**SCE comments on the CAISO's Revised Straw Proposal on
Multi-Stage Generator Modeling**

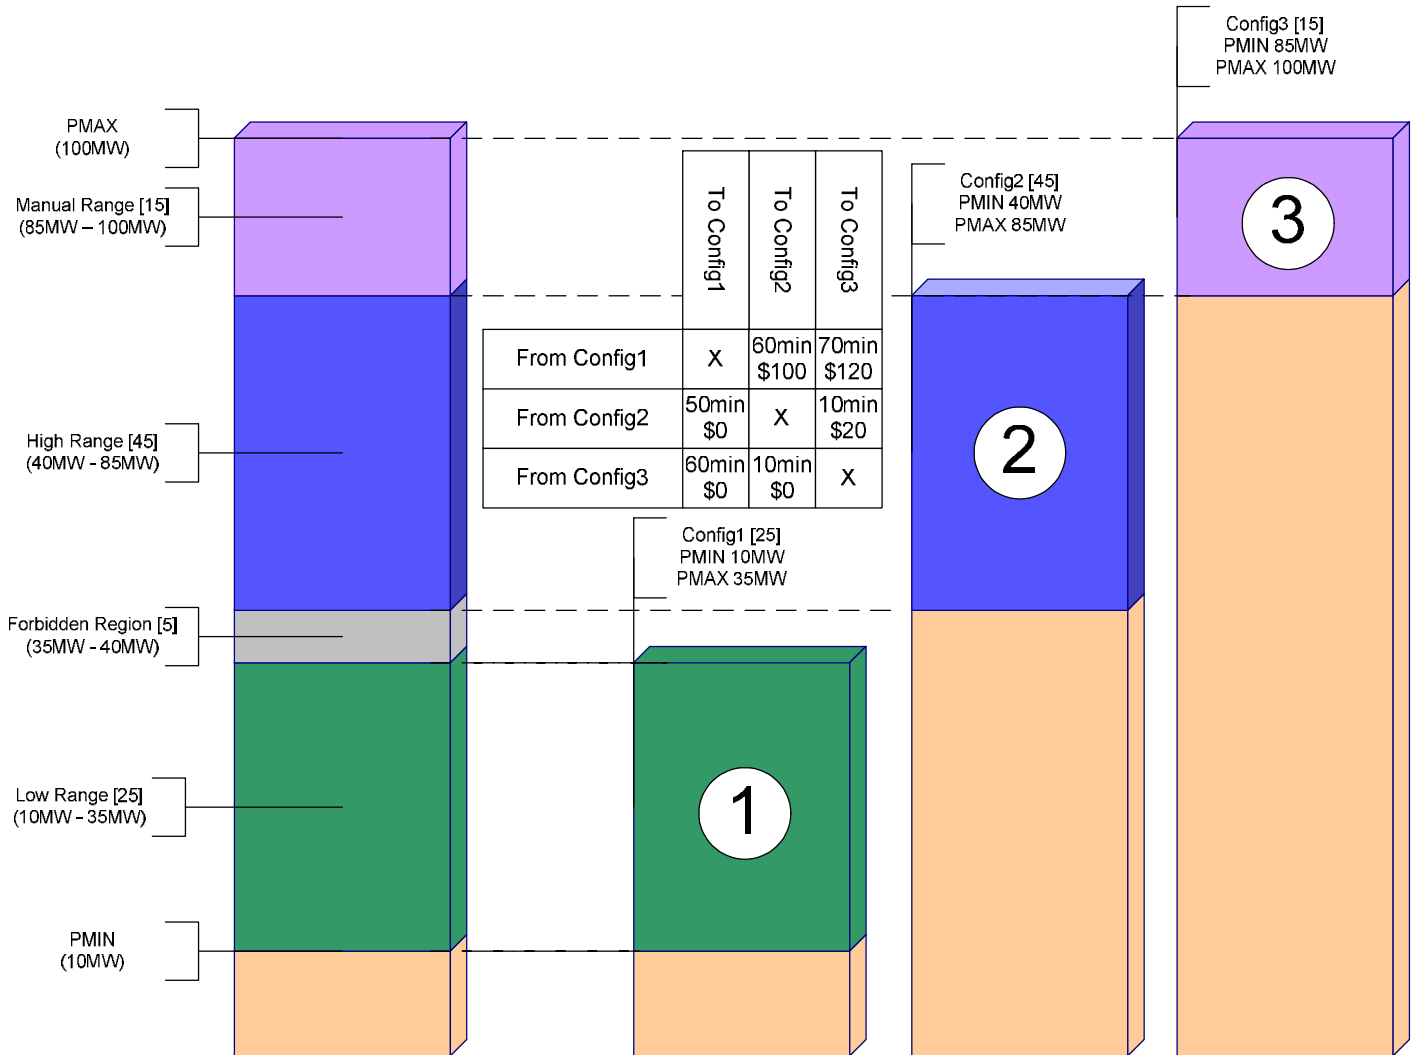
Example: Below is a non-combined cycle example. This example is also available in MS Visio file format so the ISO can modify as they see fit. We encourage the CAISO to also develop a combined cycled example that may be referenced during future discussions.
